Response re: SSD 7172 Hume Coal Project & SSD 7171 Berrima Rail Project

**Re: SSD 7172 Hume Coal Project & SSD 7171 Berrima Rail Project –
Response to submission by Mr Derek White**

Department of Industry (Water) additional technical advice to the Independent Planning Commission (IPC) about the Hume Coal Project

Figure 2.1 Example of AHTM Drill Rig (Palaris 2019)

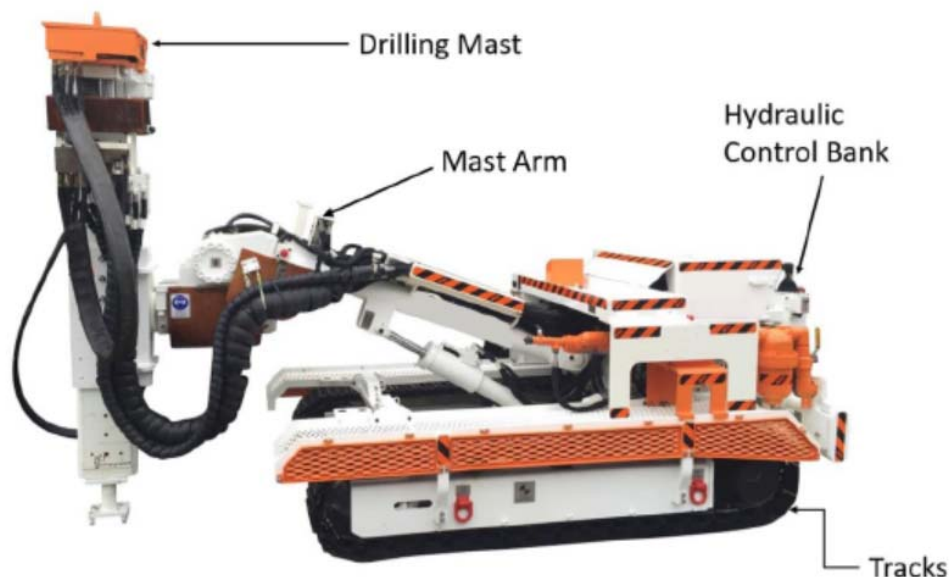
The modification of the AHTM drill rigs by the manufacturer for Hume Coal's drill rigs have not been tested under coal feather mining conditions, and modifications to use umbilical hydraulic lines extending from the front of the drill rigs to the end of the coal void loses its credibility in work practice in that coal voids vary in length and diameter and will be all drilled at certain inward distances depending on the length of the coal seams.

Hume Coal plan to utilise a modified air/hydraulic track mounted (AHTM) drill rig to carry out the process of reject emplacement (refer to Figure 2.1). An AHTM drill rig is a piece of machinery commonly used underground for the installation of rock bolts in the underground roadways. These machines comprise a track mounted drilling mast where all motors are driven by compressed air (rotational motor, feed motor and tram motor). The rotational and feed motors are used for drilling and installing the rock bolts whilst the tram motor drives the tracks which are used for manoeuvring the machine.

Hume Coal will collaborate with the equipment manufacturer (OEM) to modify the AHTM rig in order to remove the drilling mast and replace it with a discharge nozzle that will mount onto the mast arm. This nozzle will be used as a discharge point to distribute and emplace the reject material. A discharge line of 90 mm internal diameter transporting the reject material would then be connected to the nozzle as a means of feeding the reject to the discharge point.

Additionally, Hume Coal will collaborate with the equipment manufacturer (OEM) to remove the hydraulic control bank that operates the tracks and mast from the body of the machine by the use of umbilical hydraulic lines extending from the rig to the entrance of each plunge. By doing this, the equipment operator will be able to activate all functions of the rig remotely.

Figure 1 - Figure 5.1 of GEOTLCOV25281AB-ACA, Hume Coal Project, Groundwater Assessment Volume 1: Data Analysis 17 November 2016. Note red arrows and boxes added by DoI Water.

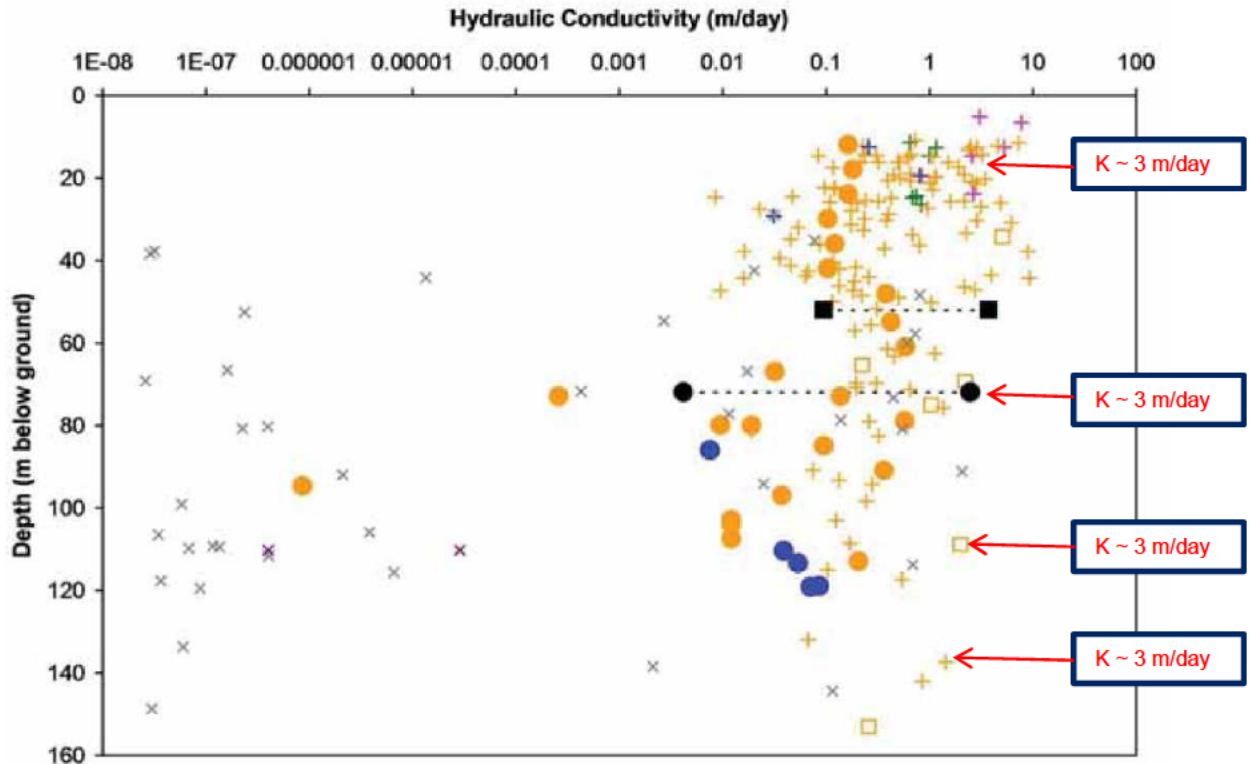
Attention is drawn to Figure 4.5 of GEOTLCOV25281AB-ACB plus Figures 5.1 and 5.2 of GEOTLCOV25281AB-ACA. It is clearly observed that predominantly in the Hawkesbury Sandstone (but also in the Basalts, Wianamatta Group and Wongawilli seam):

- K values in the range 0.01 – 5 m/day occur to depths of between 120 - 160 m and are numerous.

- The data presented by the proponent does not demonstrate clear field evidence for the assertion that hydraulic conductivity decreases with depth. In contrast as demonstrated in the above figure, conductivity remains high at depth. The upper range values are of approximately 3 m/day occurring to depths of 140 m.
- The linear regression as applied by the proponents modelling consultant to prove a decrease of hydraulic conductivity with depth is in the opinion of DoI Water an unreasonable and inappropriate fit of the data.
